Downtown Subarea Plan Proposed Amendments:

The Downtown Subarea Plan can be seen: <http://www.ci.bremerton.wa.us/371/Downtown> or at the City of Bremerton website: www.ci.bremerton.wa.us: Home-Our Government-Community Development-Downtown. The following are proposed amendments to the development regulation portions of the Downtown Subarea Plan.

Setbacks WC Zone

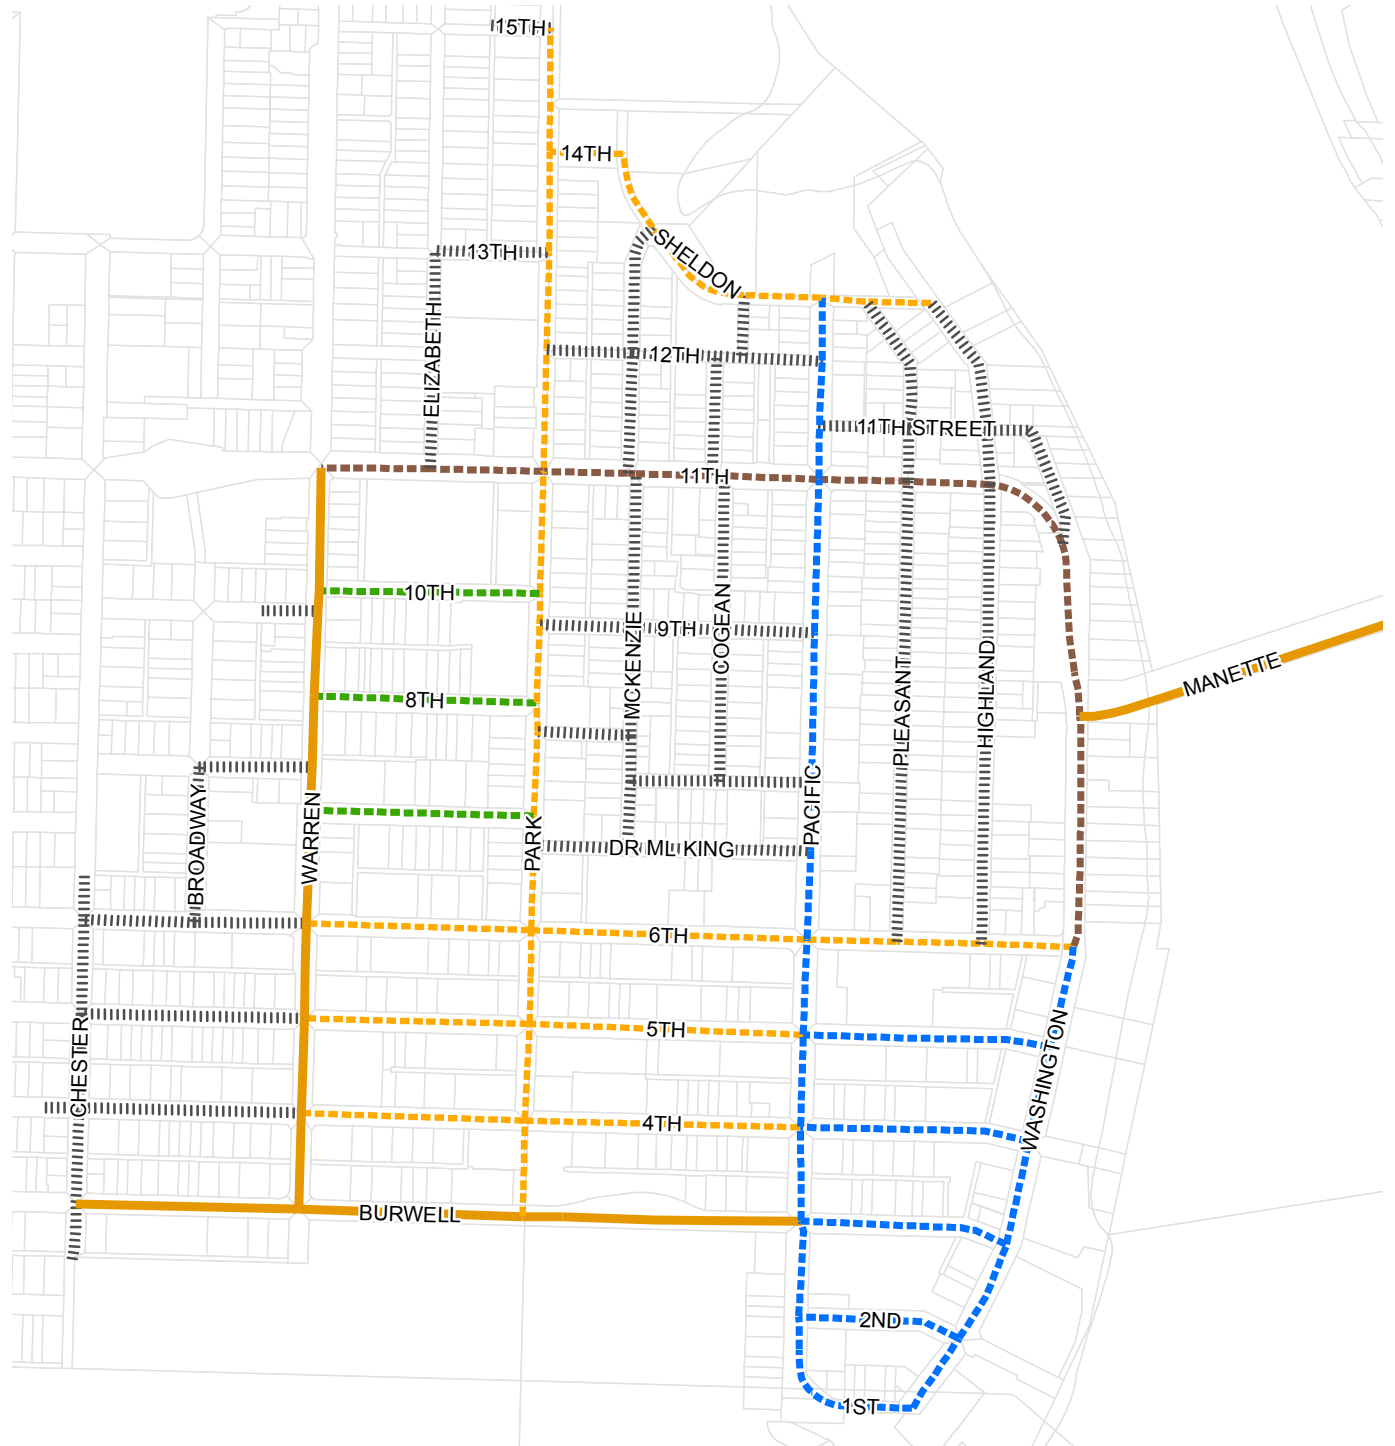
Page	Title or Figure for Proposed Revisions	Proposed Revisions to the Development Standards Portion	Other Information
Development Standards: page 6-139	Setbacks within Warren Avenue Corridor Zone	As proposed Amendment #3 for the Downtown Subarea Plan Road Typology Map is proposed to be revised to include <i>Residential Streets</i> , the Warren Avenue Corridor needs to be revised to include the following addition to the chart:	Use same criteria for Residential Streets with Multifamily 1+2 zone development standards for <i>Residential Streets</i> .

Street Type	Structure Height Condition	Building Frontage (Front Setback)	Street Allocation	Minimum Side	Minimum Rear
<u>Residential Street</u>	<u>Less than 40' in height</u>	<u>10'</u>	<u>4'</u>	<u>5'</u>	<u>15'</u>
	<u>Greater than 40' in height</u>	<u>16'*</u>	<u>4'</u>	<u>15'</u>	<u>15'</u>

*Portions of the front façade above forty (40) feet must include a change in material to designate street wall.
